Project No. 12091-01

**Subject: Preliminary Geotechnical Evaluation and Response to City Review Comments for Proposed San Pedro Distribution Center, 1599 W. John S. Gibson Boulevard, Los Angeles, California**

## **5.0 RESPONSE TO CITY REVIEW COMMENTS**

***Response to Comment No. 14***

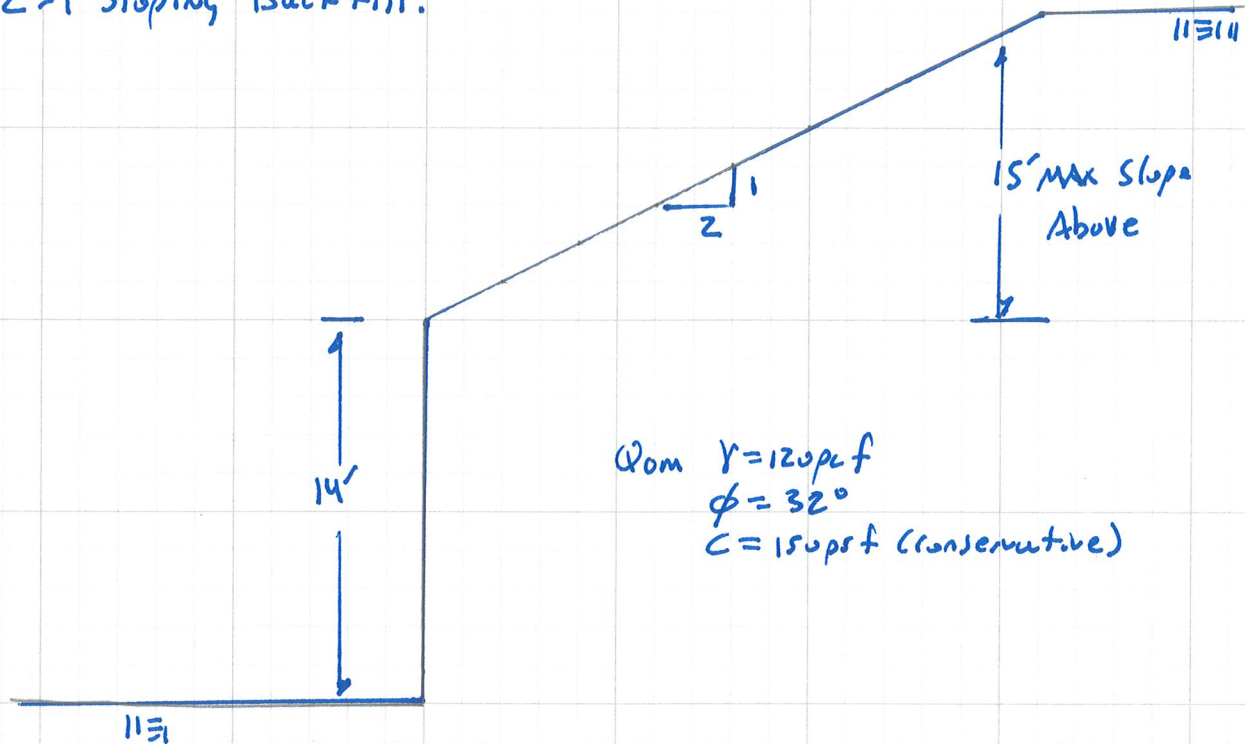
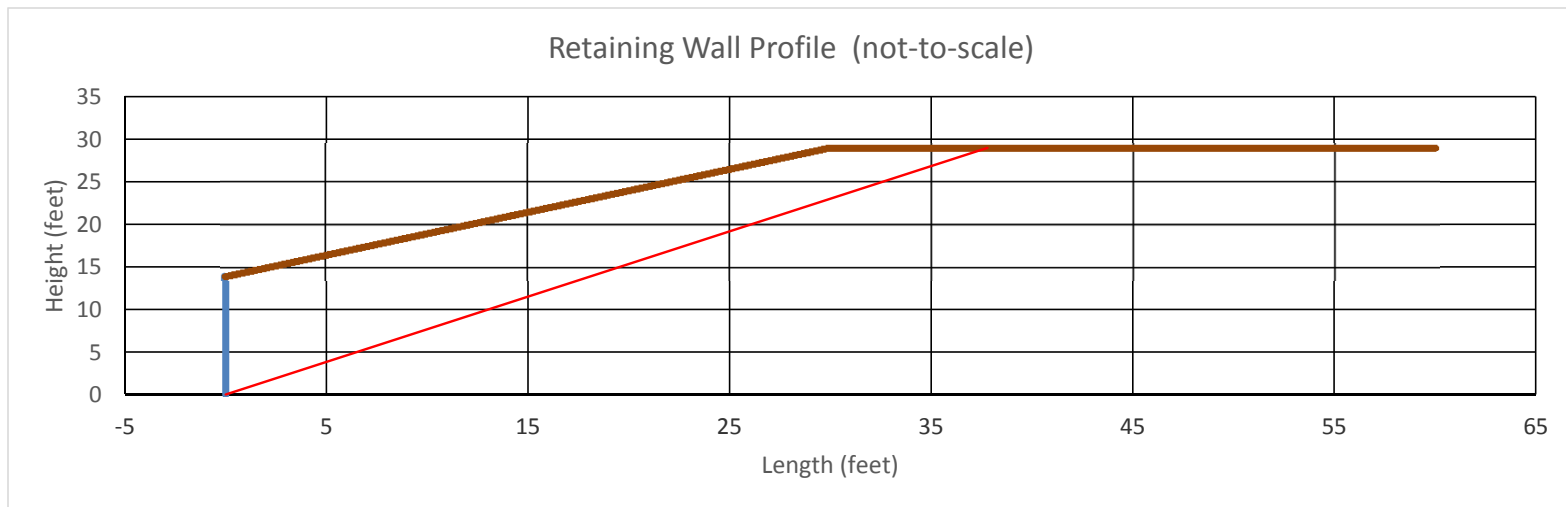
“Provide retaining wall/basement design calculations and recommendations for lateral earth pressure due to earthquake motions for walls higher than 6 feet, as required by Section 1803.5.12 of the 2017 Los Angeles Building Code.”

**Geotechnical Map**

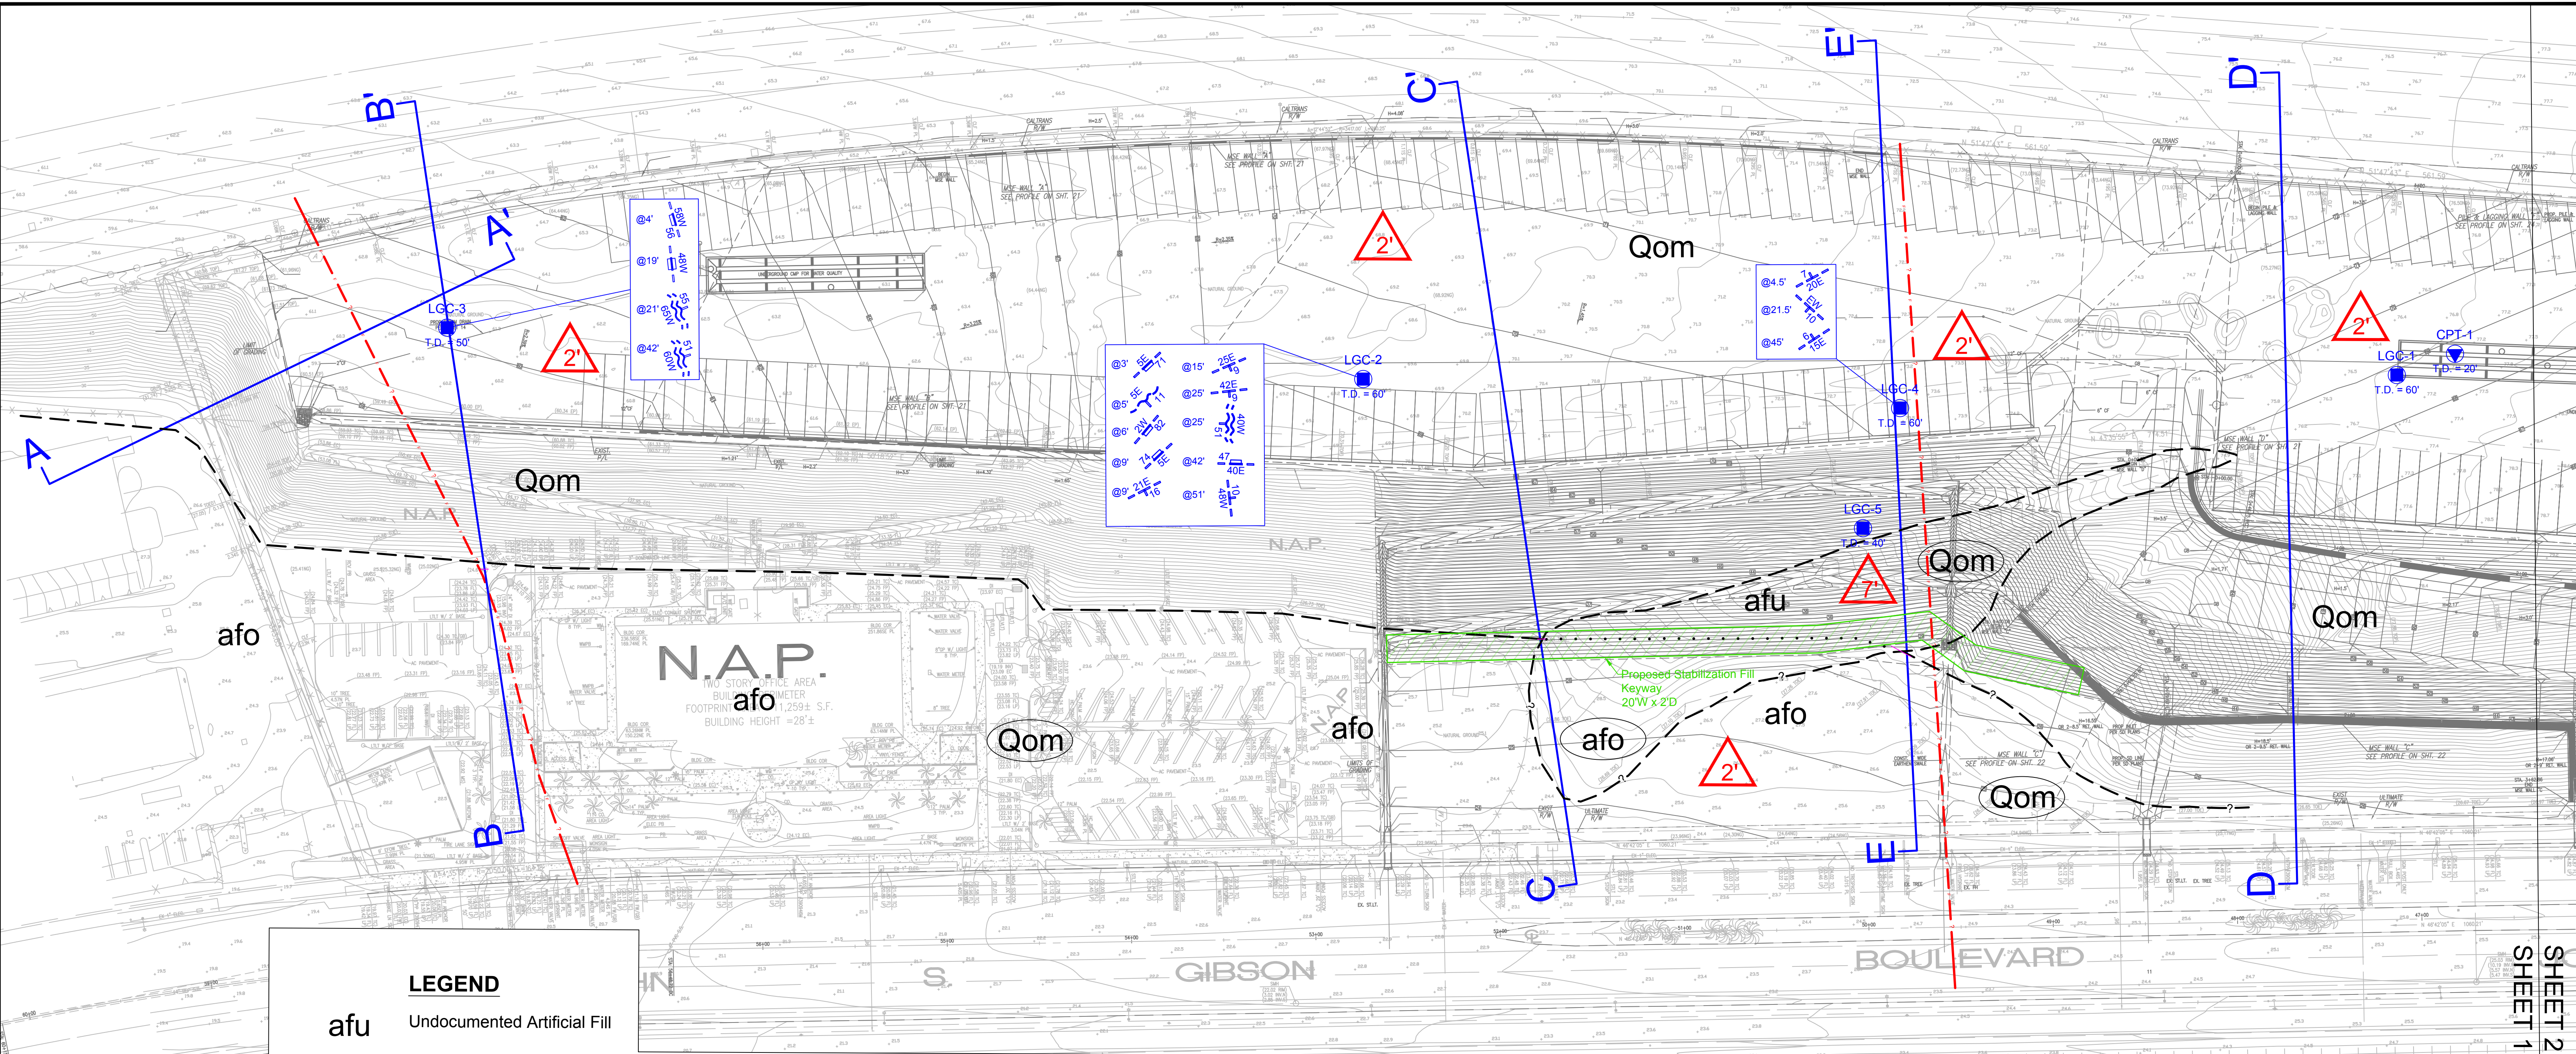
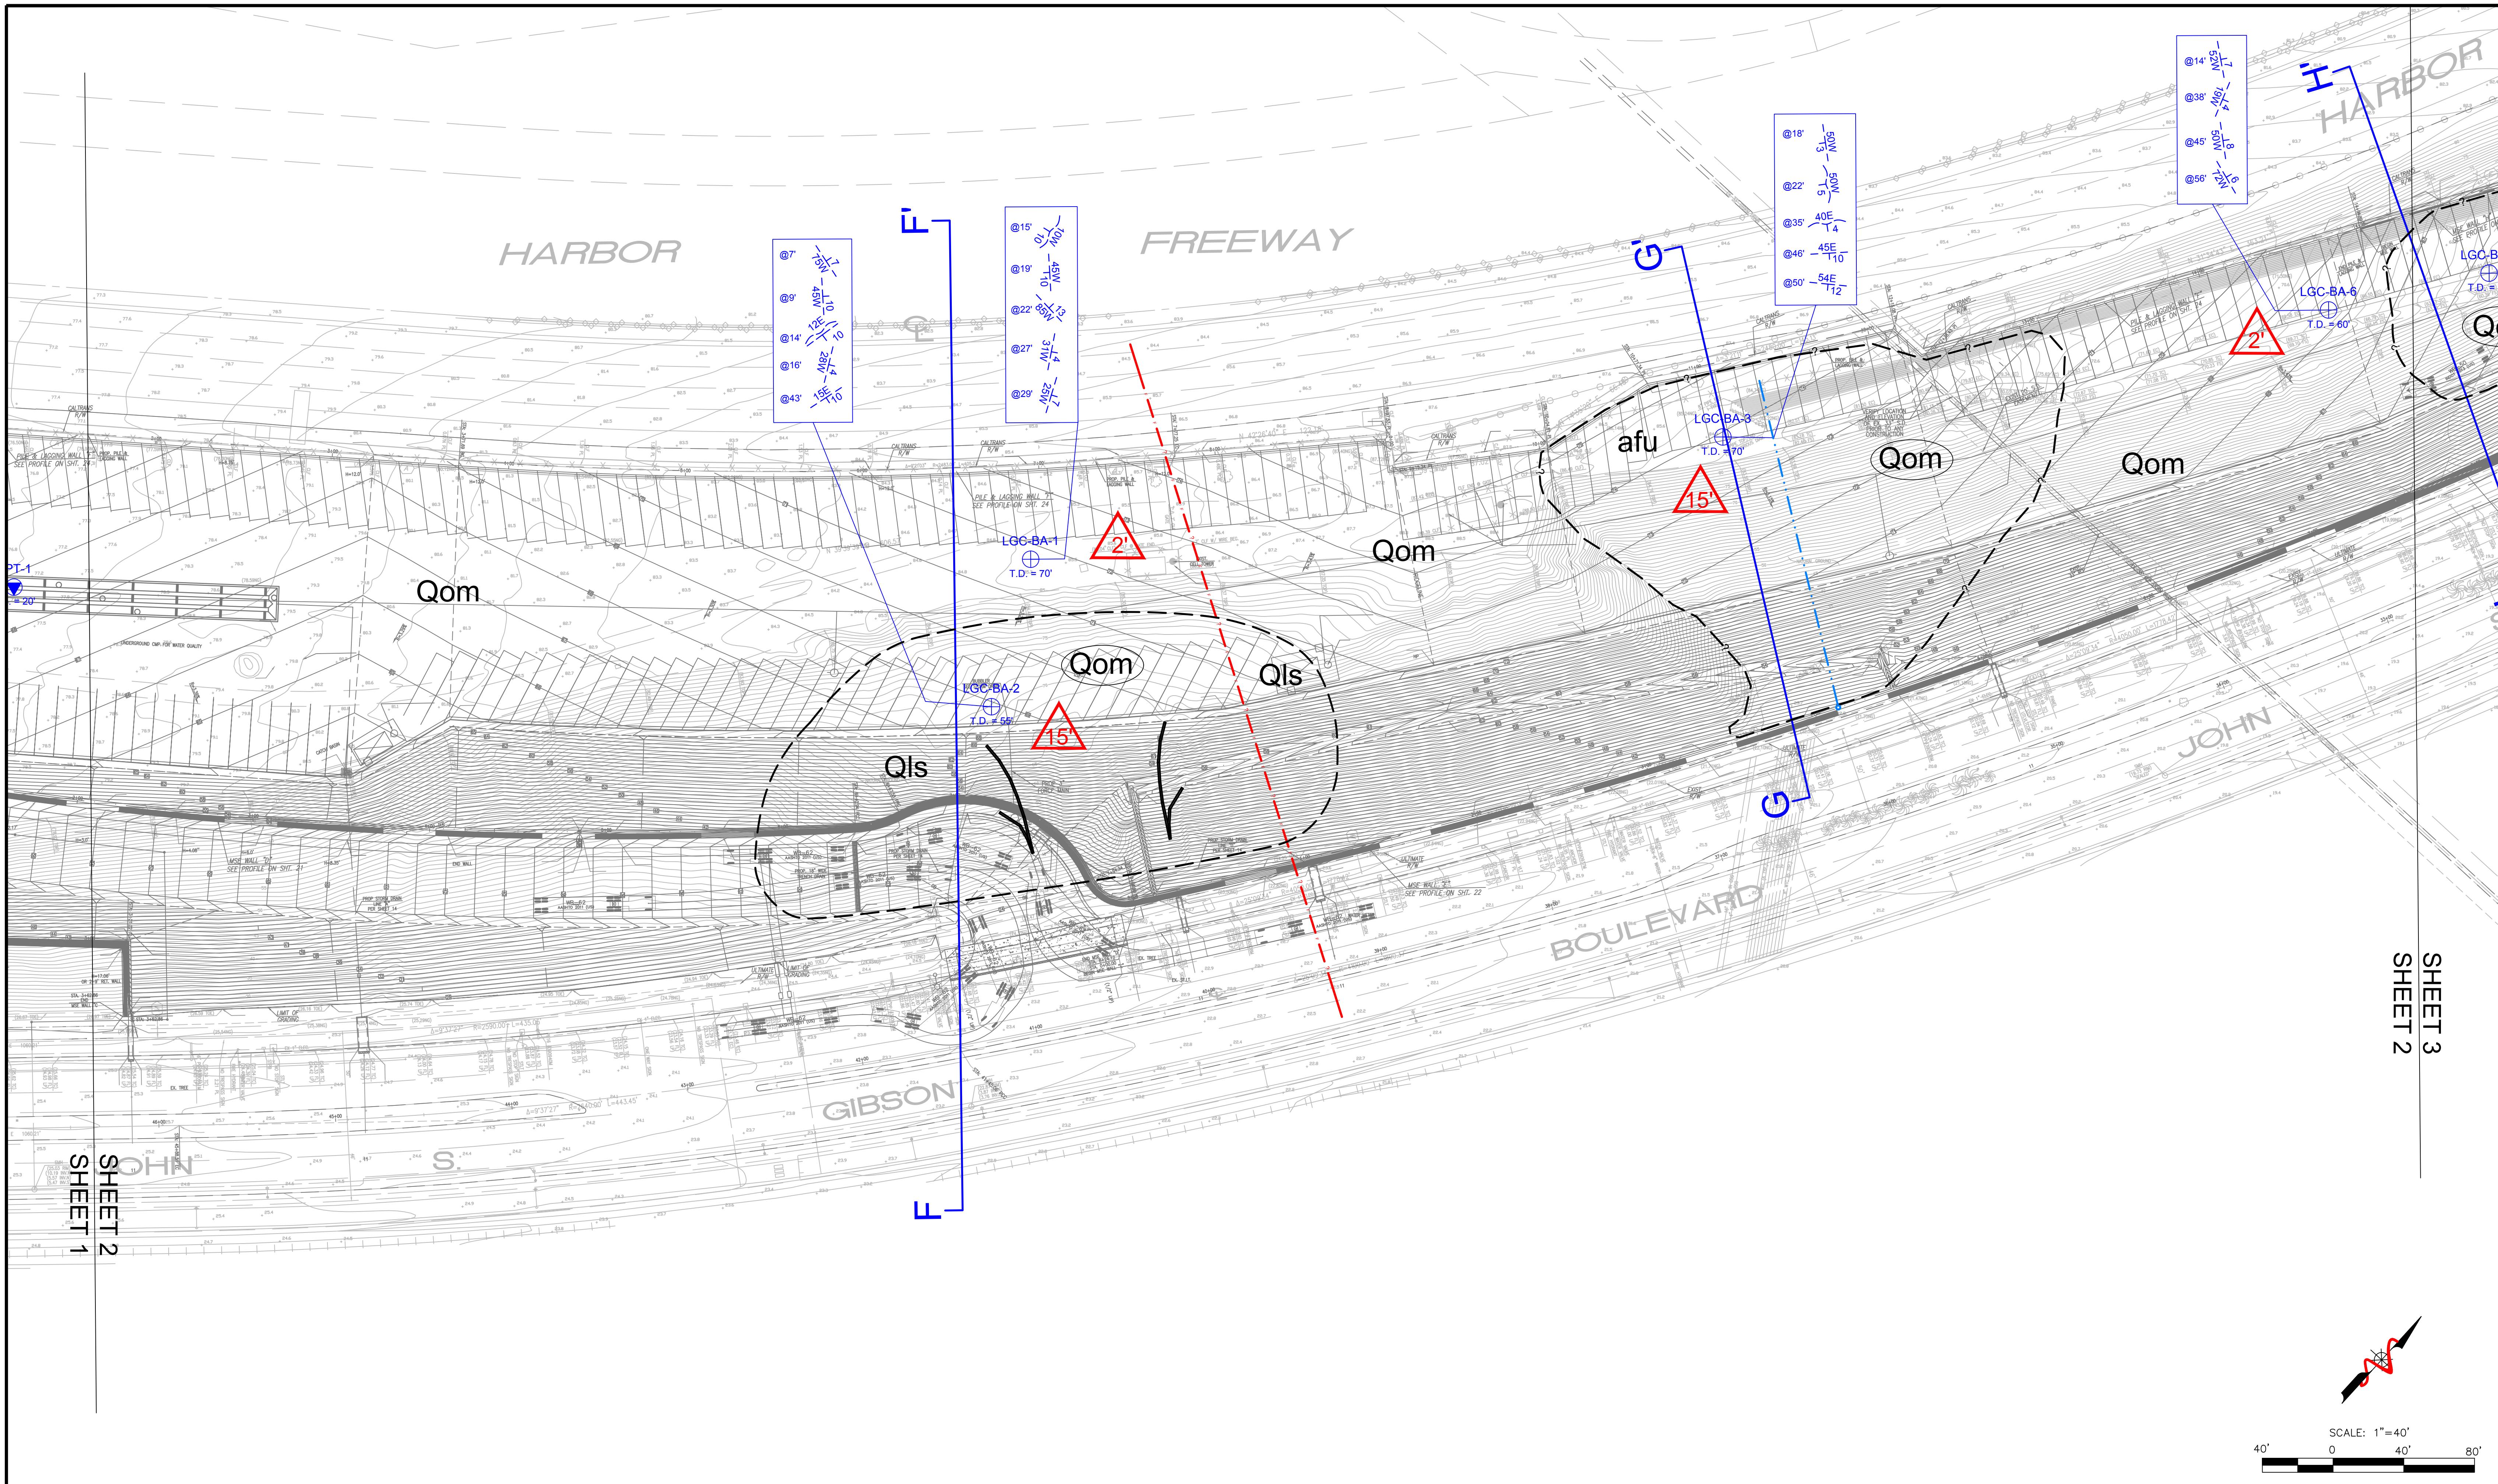
“No map was provided with the current update report reflecting the proposed site conditions. Provide recommendations and revise the plan(s) and cross sections(s) for providing the required building setback from the toe of the ascending slope as specified by Code Section 1808.7.1.”

Refer to the attached Geotechnical Map (Sheets 1 through 3). No building structures are planned for the site.
